Addendum #1

Lewiston Readiness Center Roof Replacement Project
Project No. 23SR10-461-D, Bid Number #16-040

Directorate of Facilities Engineering

5 April 2016

SHEET ID:
A-111
SHEET: 14 of 36

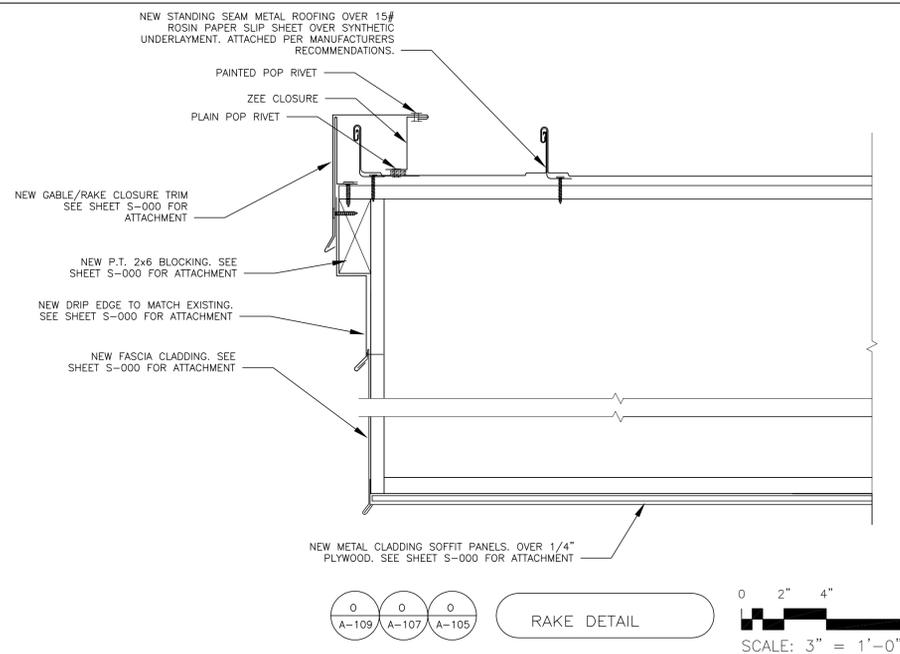
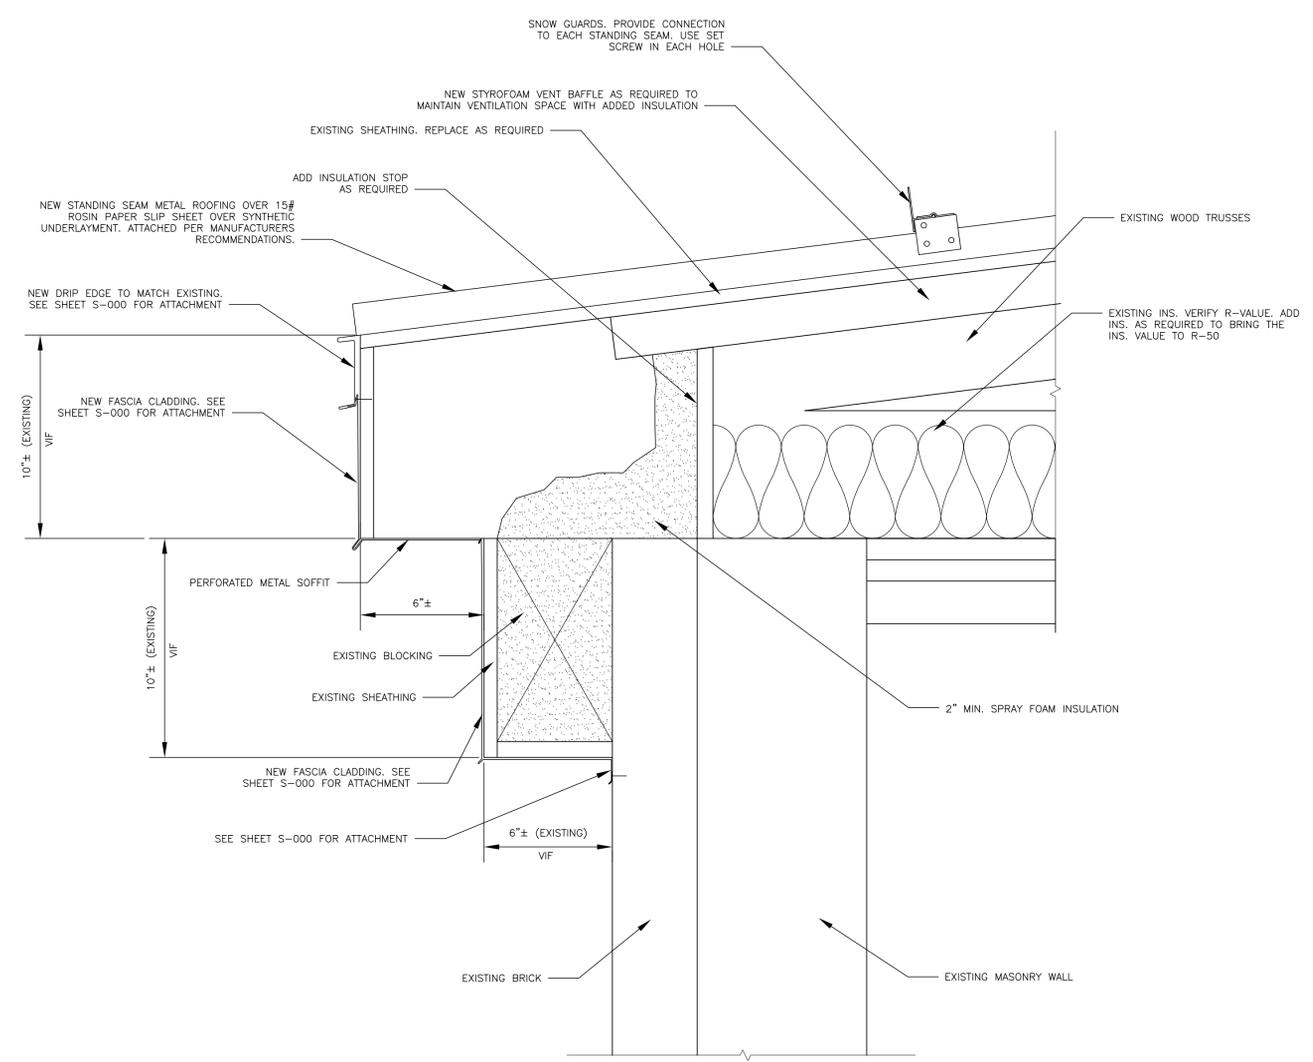
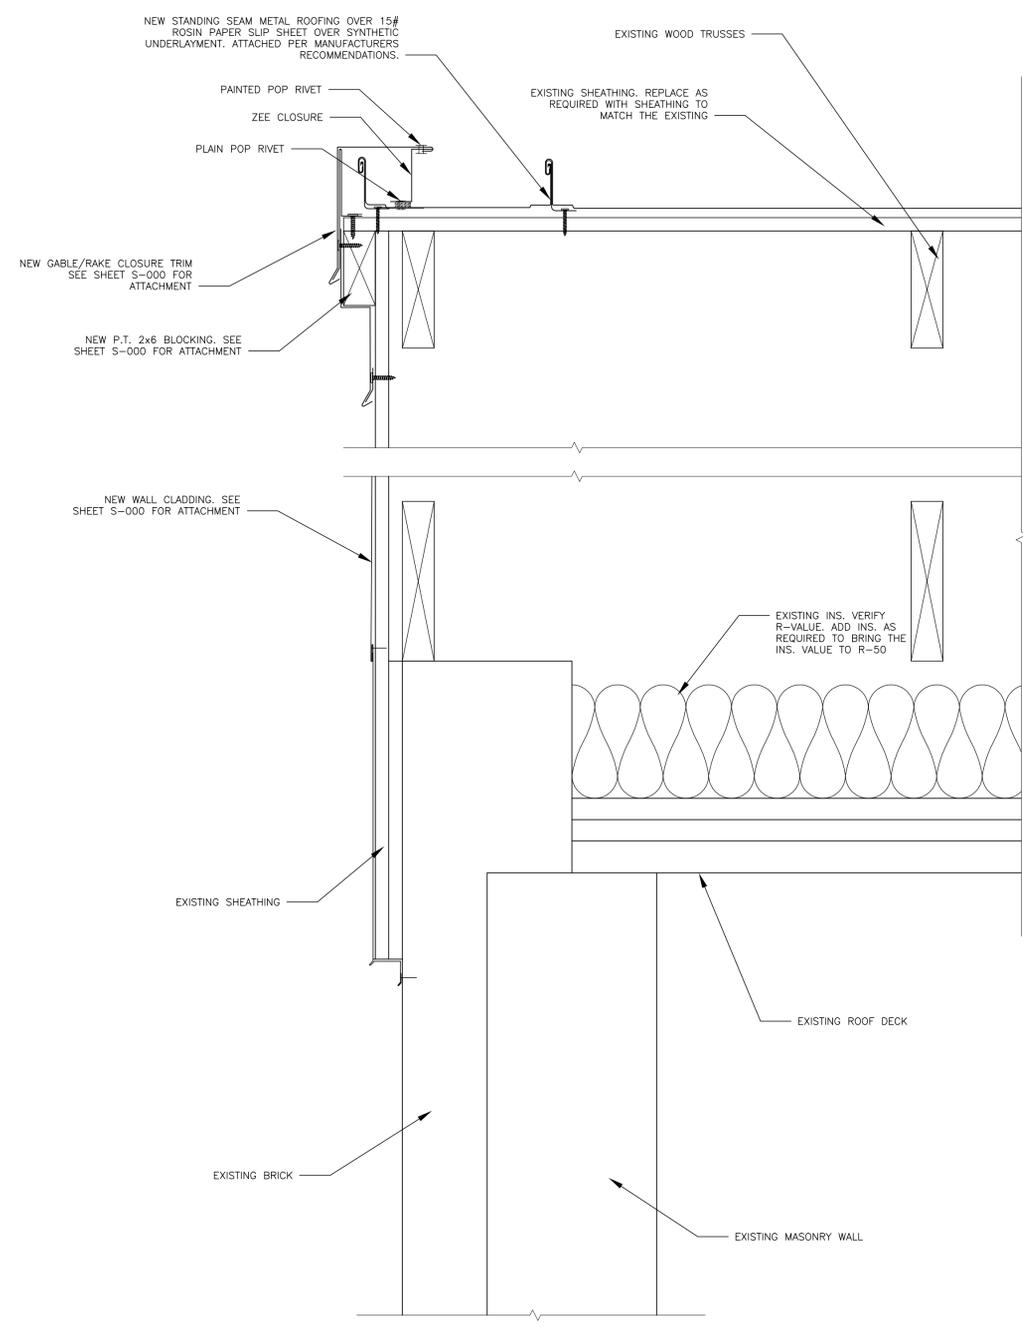
- (10) Sheet A-111: Detail C, Change attic insulation to R-50 and added spray foam insulation to the eave/soffit. Detail D, Change attic insulation to R-50.

SHEET ID:
A-113
SHEET: 16 OF 36

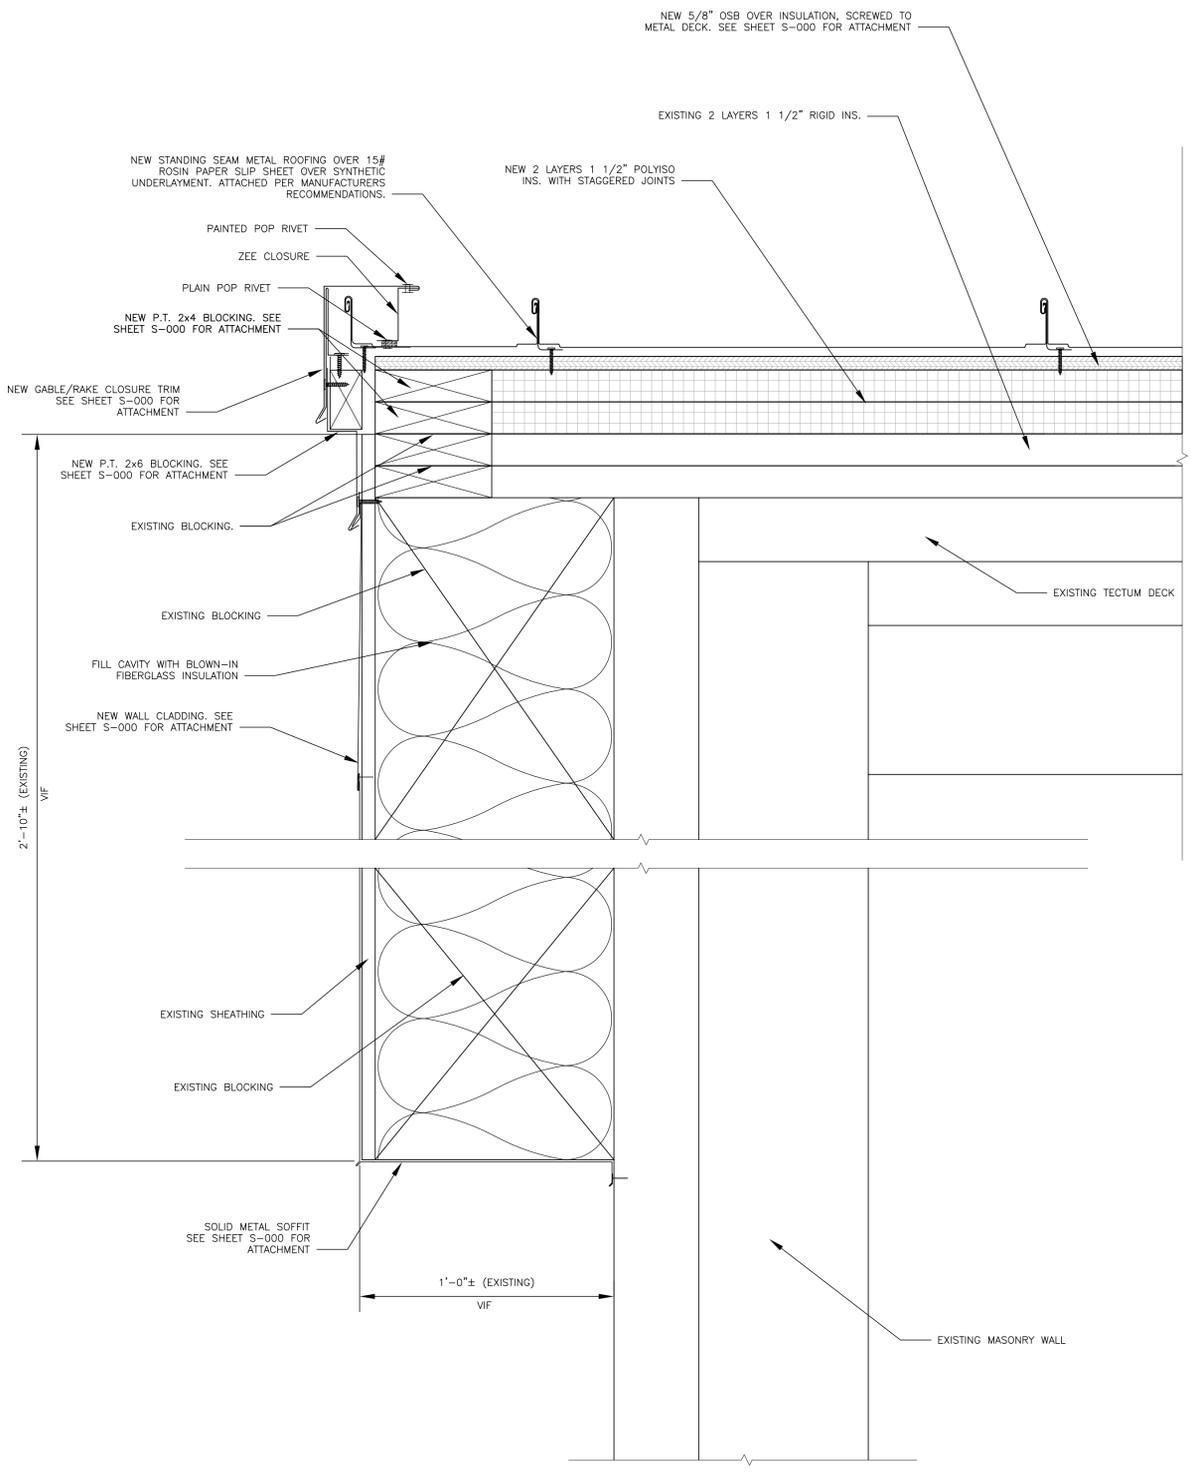
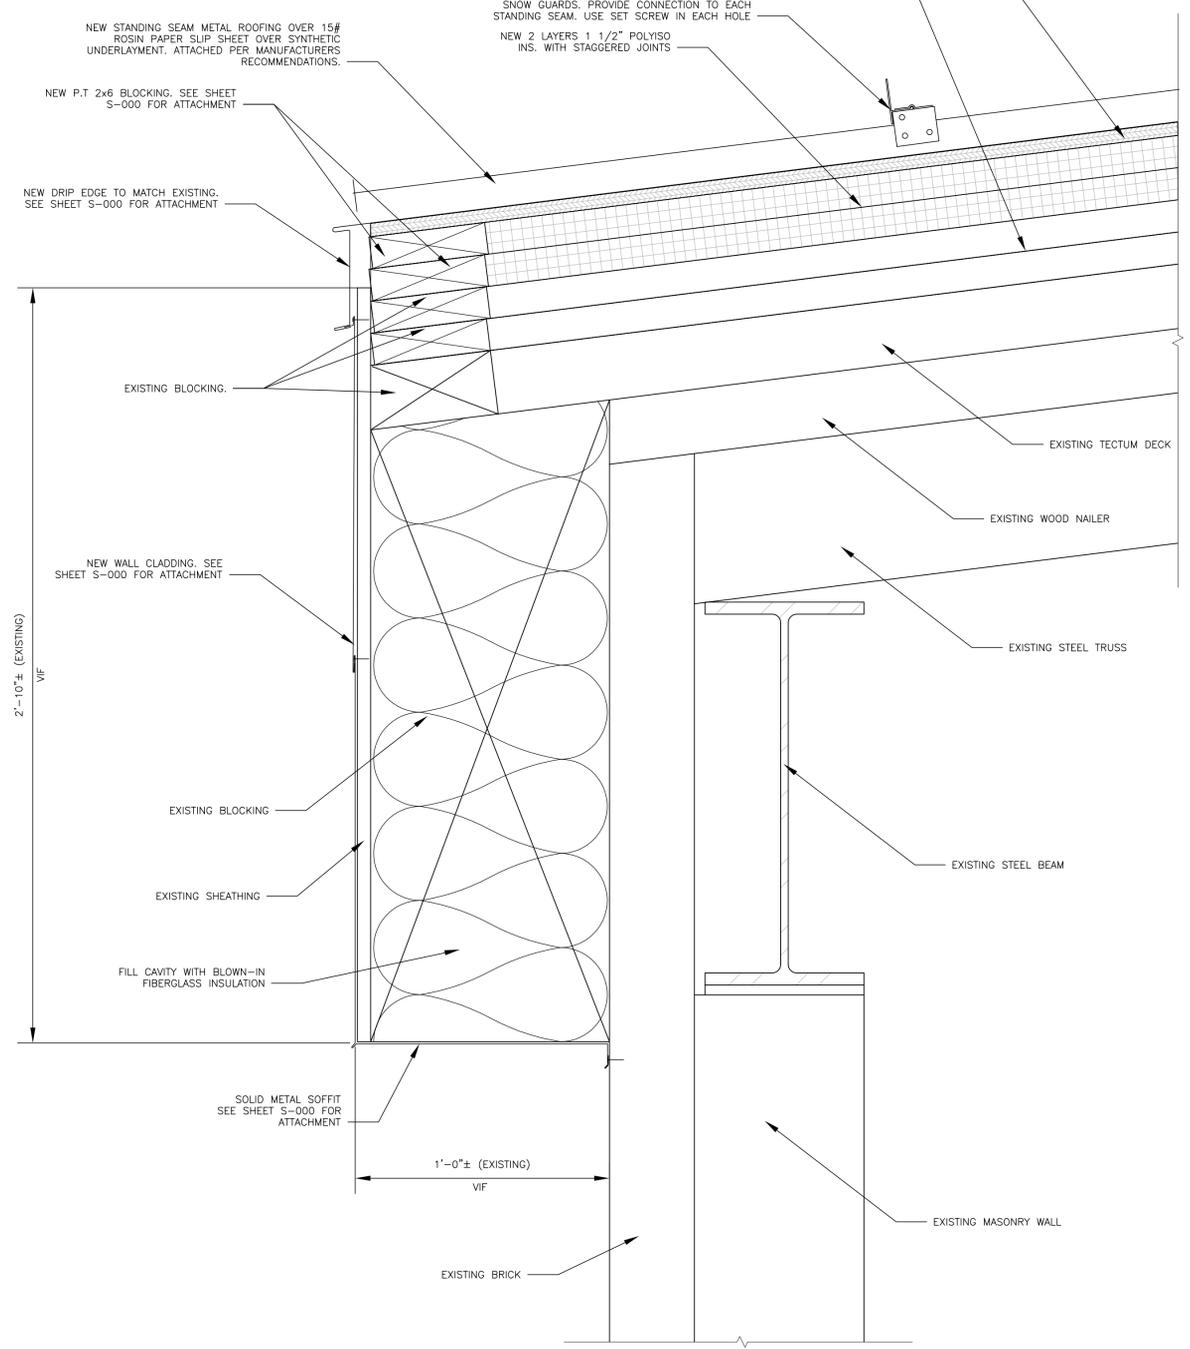
- (11) Sheet A-113: Detail J, Added blown-in fiberglass insulation to eave soffit. Removed existing OSB. Detail K, Added blown-in fiberglass insulation to gable soffit. Removed existing OSB.

SHEET ID:
 A-116
 SHEET: 19 of 36

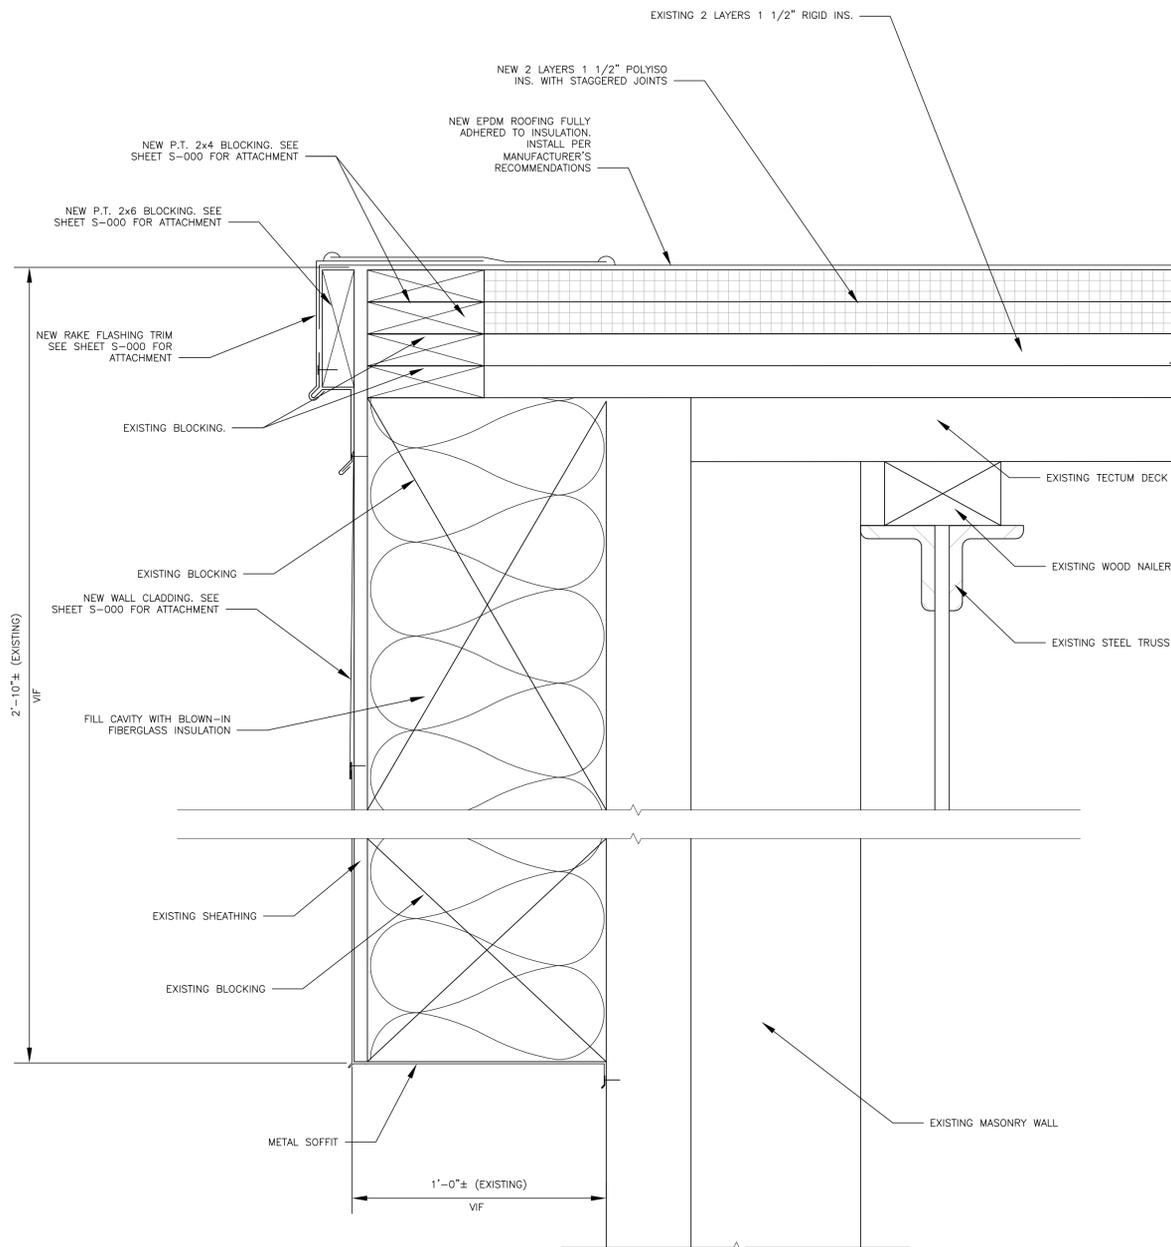
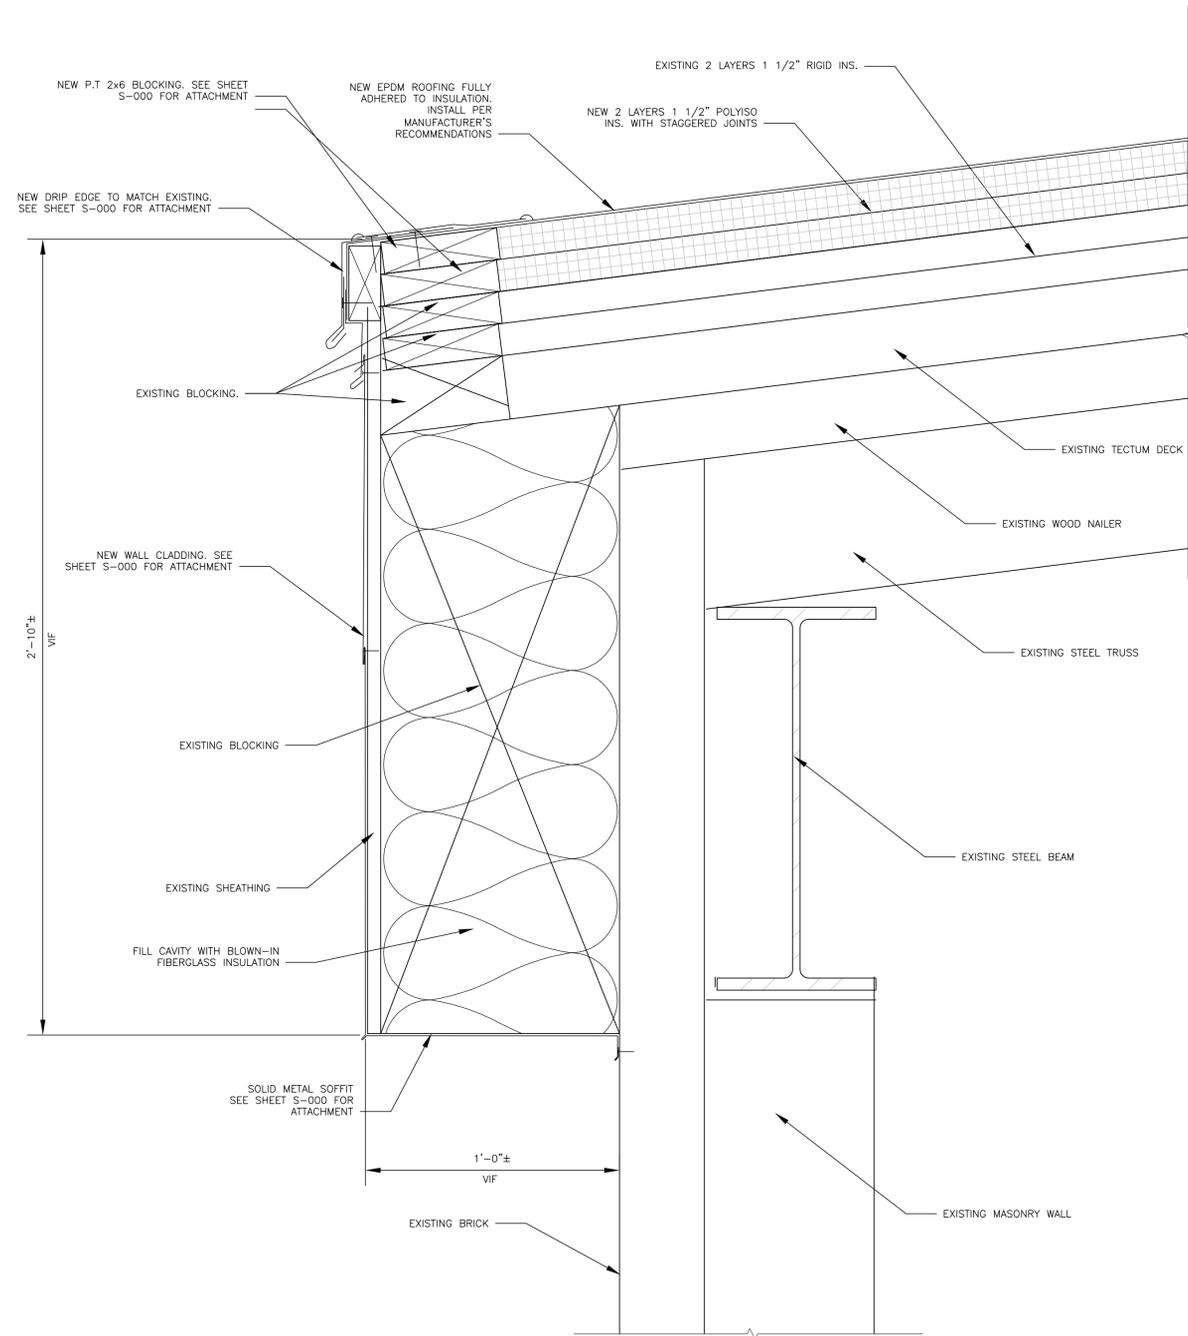
- (12) Sheet A-115: Detail W, Change attic insulation to R-50. Detail V, Change attic insulation to R-50.
- (13) Sheet A-116: Detail DD, Added blown-in fiberglass insulation to eave soffit. Removed existing OSB. Detail FF, Added blown-in fiberglass insulation to gable soffit. Removed existing OSB.
